Dear Dr. Martin Mergili,

thank you very much for your valuable and constructive comments and suggestions. We agree with most of them (see our responses below). We believe that they will help to improve overall quality of the manuscript.

Figure 1: Comparison between sin α, tan α and tan (α/2)

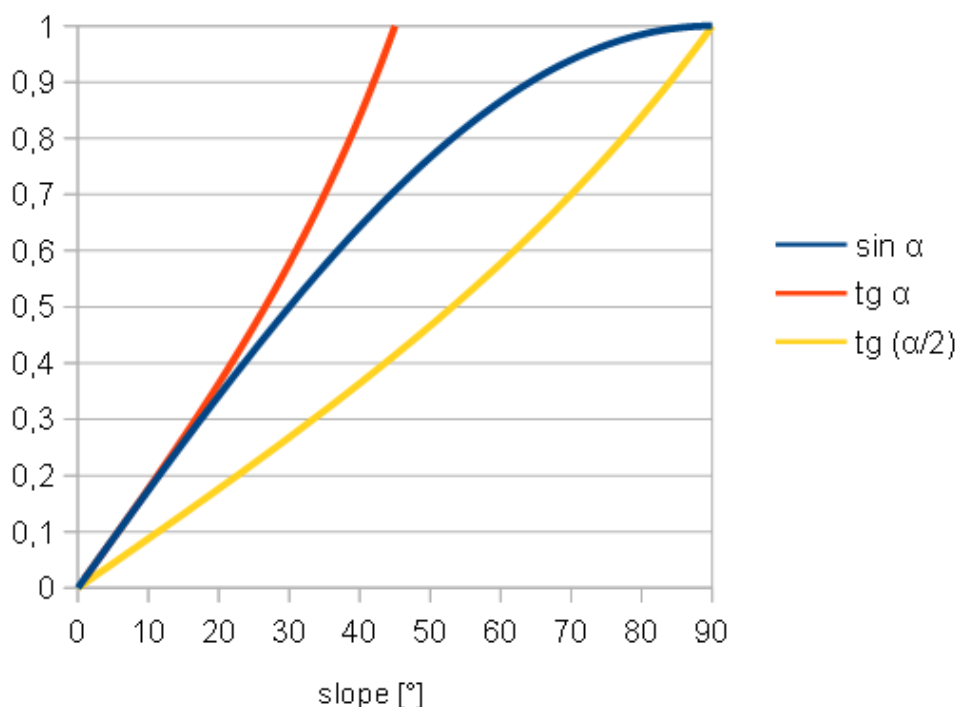
2401, Eqs. 2 and 3: Why do you use the sinus of the slopes? From a geotechnical viewpoint, the tangent would be more appropriate as – at least for cohesionless materials – the safety factor is tan phi /tan slope.

- for our purpose of simplified description of susceptibility of moraine slopes to slope movements (not based on geotechnical viewpoint), we believe, it is more important to stress rapidly increasing susceptibility between slopes 0-60°, than between 60-90°, because moraine slopes steeper than cca 70° frequently failed and it is not necessary to distinct between slopes 70-90° significantly

- sin α in comparison with tan (α/2) provides higher results for the same slopes (see Figure 1), therefore we decided rather to use sin α; tan α cannot be used (because exceeds 1 for α>45°) or tan (α/2)
